ARCHITECT'S SUPPLEMENTAL INSTRUCTIONS

Project:	Lumberyard District – Buildings 2, 6, 8 & 9 Omaha, NE	Initiated By		Distributed To	
Project Number:	15927	<input type="checkbox"/>	Owner	<input checked="" type="checkbox"/>	
Owner:	Lanoha Development	<input type="checkbox"/>	Architect	<input checked="" type="checkbox"/>	
To Contractor:	Overland Constructors 5036 South 135 th Street Omaha, NE 68145	<input type="checkbox"/>	Contractor	<input checked="" type="checkbox"/>	
		<input checked="" type="checkbox"/>	Consultant	<input checked="" type="checkbox"/>	
		<input type="checkbox"/>	Field	<input type="checkbox"/>	
		<input type="checkbox"/>	Other	<input type="checkbox"/>	
Supplemental Instruction No.:	004				
Date:	July 8, 2016				
Contract Date:	February 15, 2016				
Contract For:	New Construction				
By:	Holland Basham Architects

Description: Revise data locations and deck light fixtures in the units.

6 ENLARGED TYPICAL UNIT B1 - ELECTRICAL

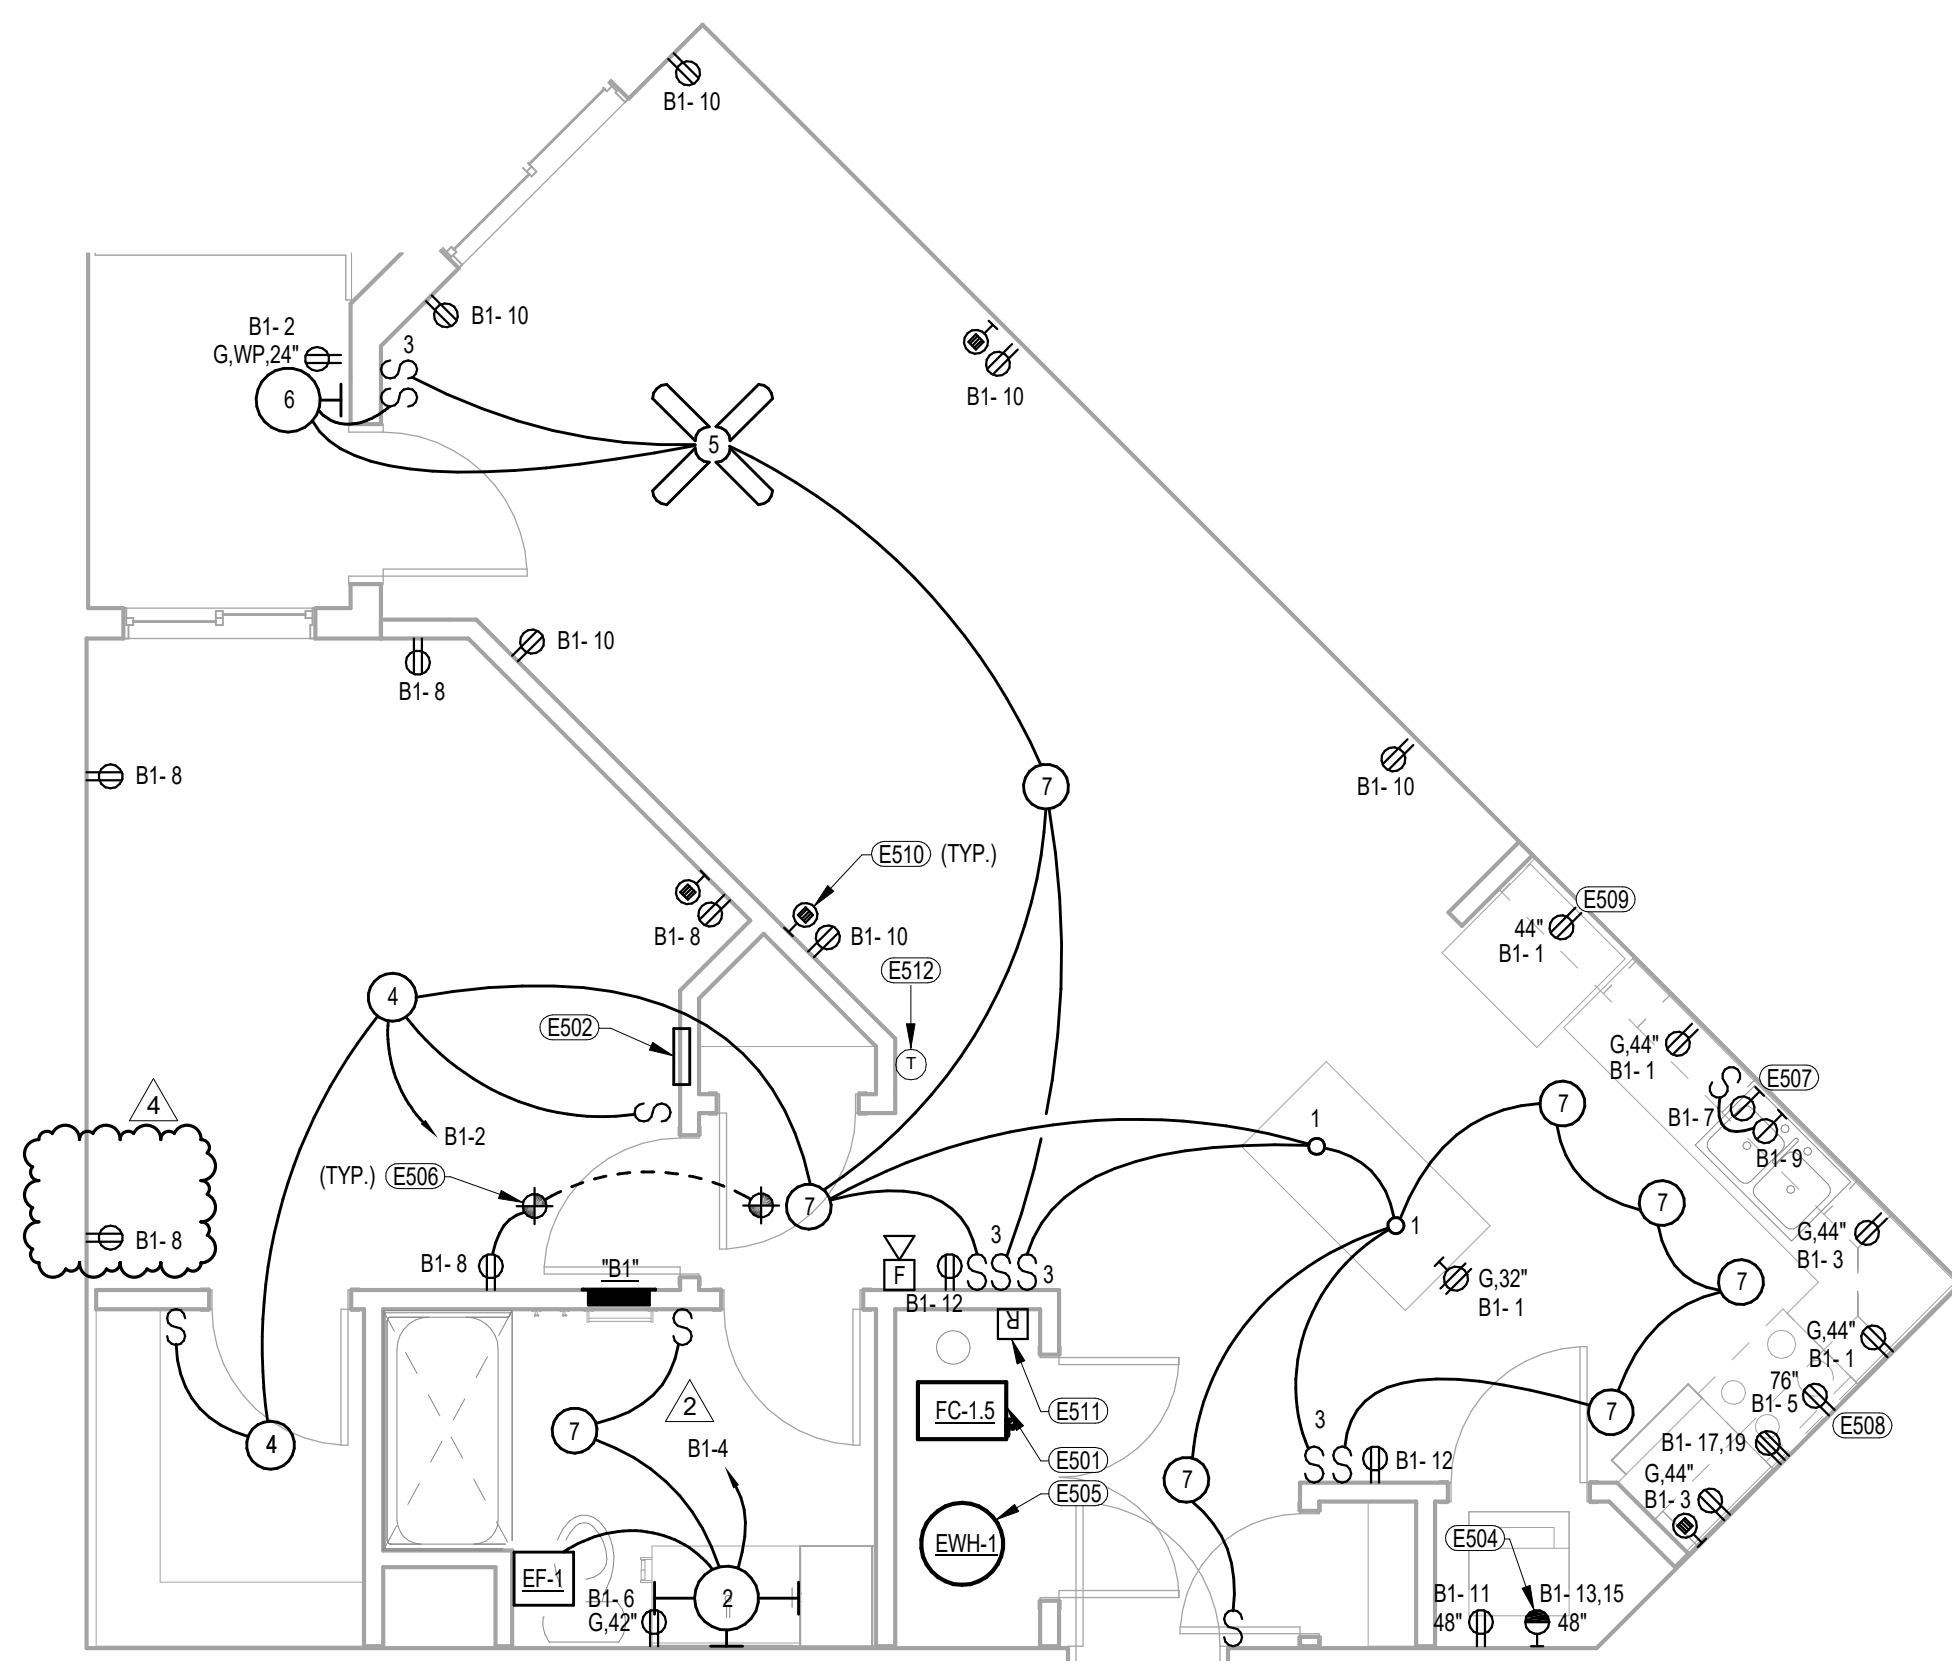
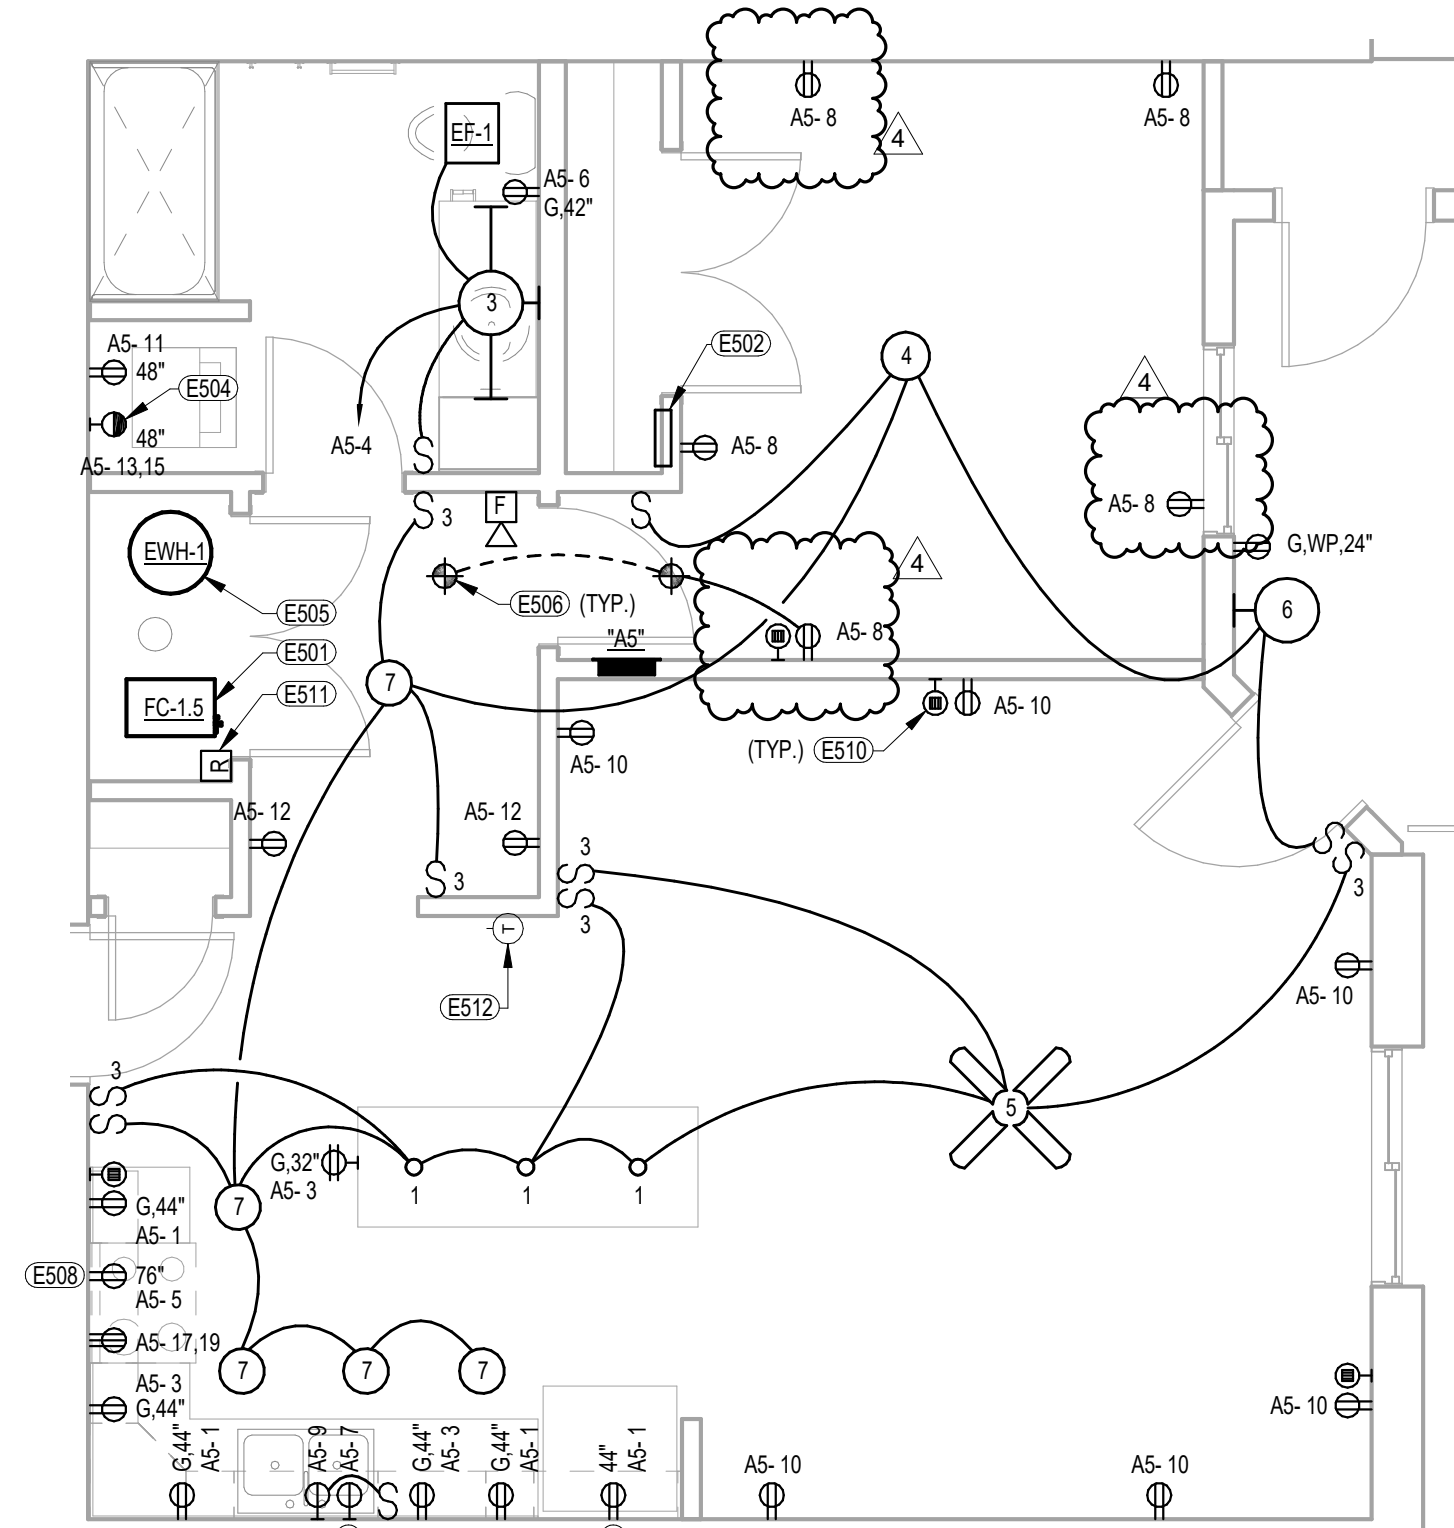
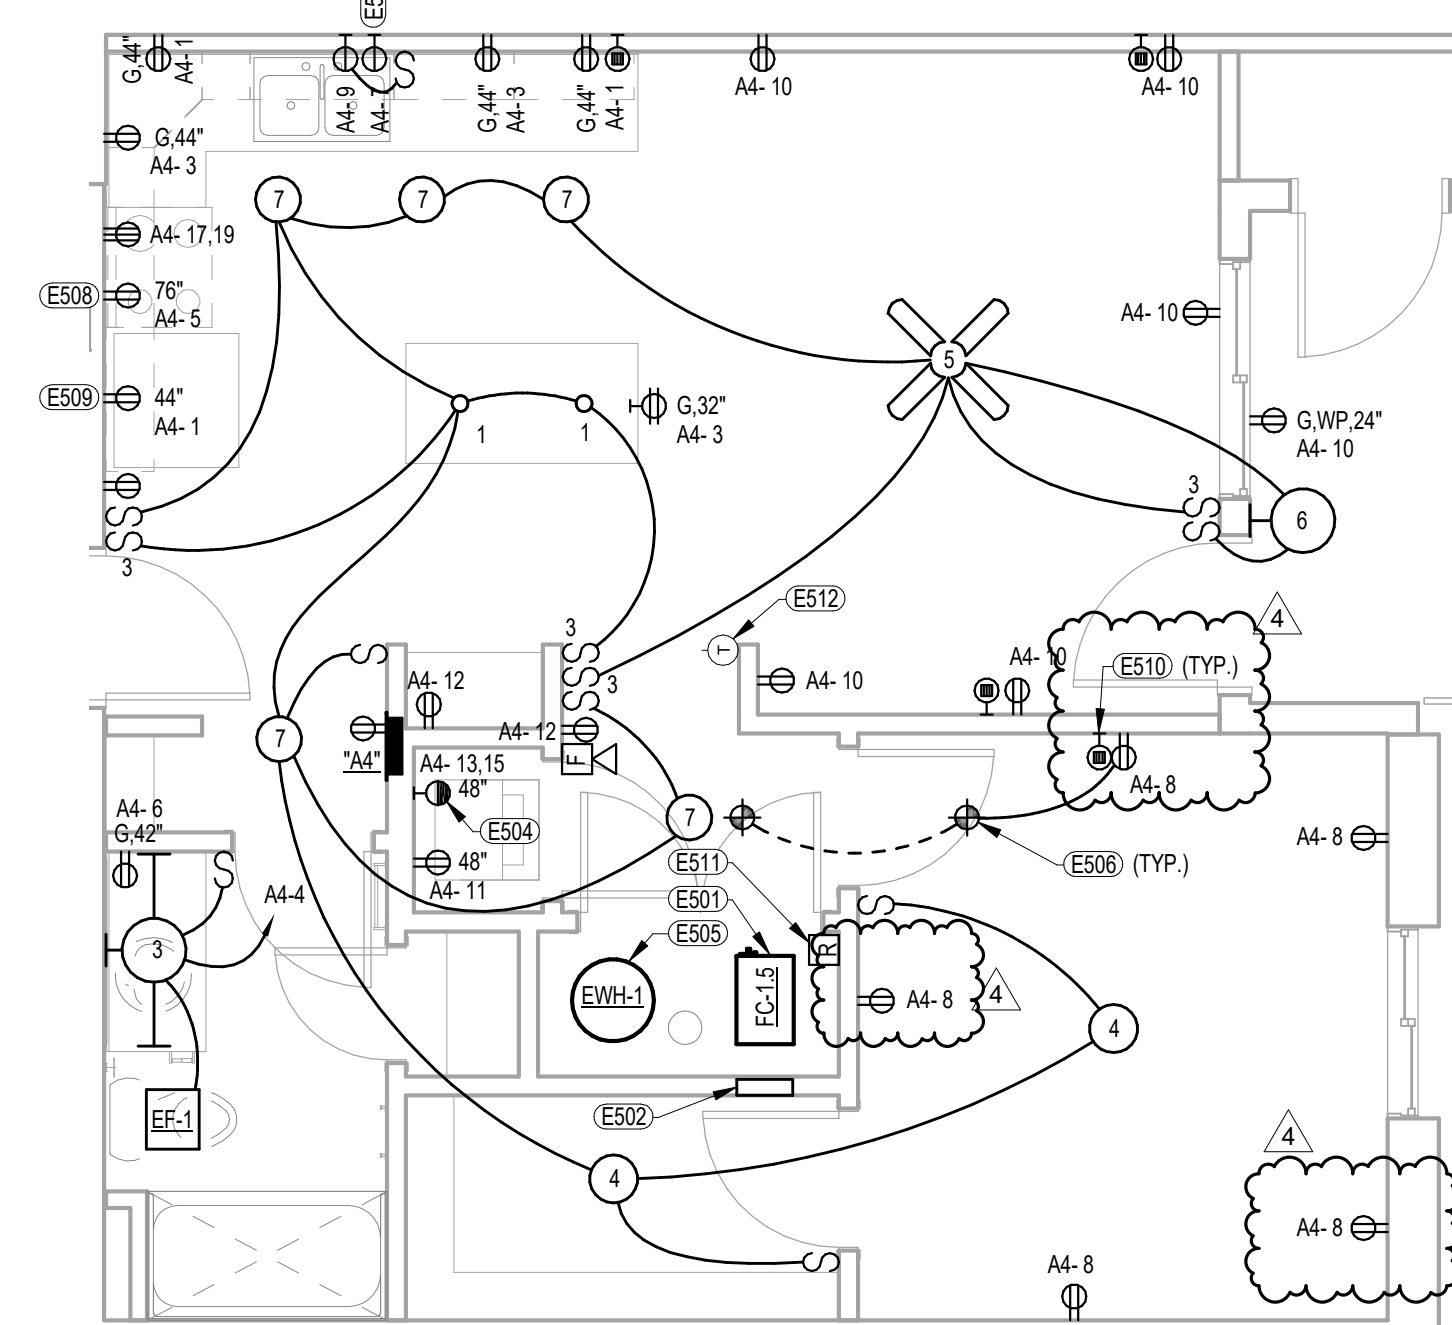
1. Sheet E6.01 – Enlarged Unit Plans - Electrical
 - a. Revise unit plans as shown in the attached Sheet E6.01.
